Worcester County Administration Office
1 West Market Street, Room 1103
Snow Hill, MD 21863
Ph. 410-632-1194

Addendum # 4 - Ocean Pines WWTP Biosolids Project
(Attachments, Clarifications, Questions & Answers)
Date of Addendum: **August 28, 2026**

HEAT TRACE CABLE DETAIL

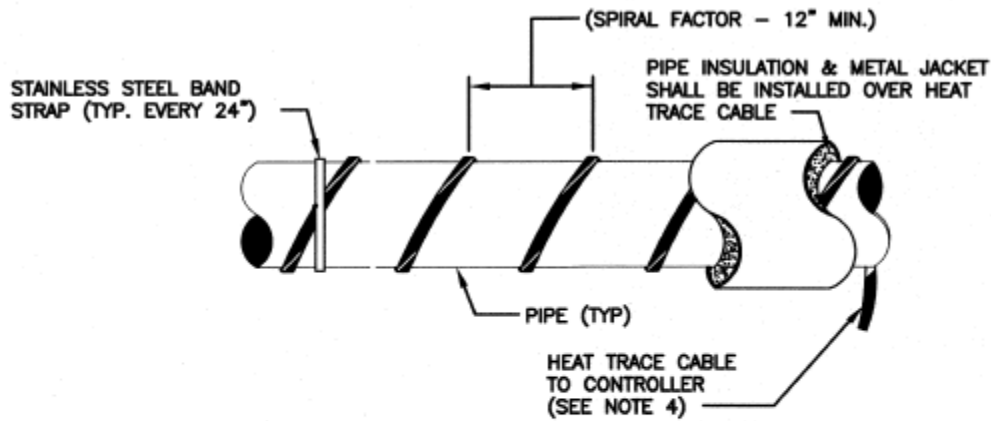
8	Heat trace is shown on Drawing E-1, but no specification or detail is shown. Who furnishes and installs the heat trace? Also, the circuit breaker in LP1 feeding the heat trace is not shown as ground-fault protected. Is ground-fault protection required? RESPONSE: The heat trace specification and detail are attached. The branch-circuit breaker for the heat trace shall be a GFI type in accordance with the attached specification and Section 427.22 of the National Electrical Code. The General Contractor shall coordinate procurement and installation of the heat trace with its subcontractors.
9	No control systems integrators (CSIs) are listed in the Specifications. Does the County have a preferred CSI or a list of approved CSIs? RESPONSE: The County does not have a preferred control systems integrator. It is anticipated that BDP Industries will program its PLC to control the belt filter press motors, VFDs, and other equipment.

1. HEAT TRACE SHALL BE INSTALLED PER MANUFACTURERS RECOMMENDATIONS ON PORTIONS OF PIPING AS SCHEDULED.
2. PROVIDE HEAT TRACE CAUTION LABELS ON PIPE INSULATION METAL JACKET.
3. CONTRACTOR SHALL INSTALL A COMPLETE, IN-PLACE HEAT TRACE CABLE AS SPECIFIED.
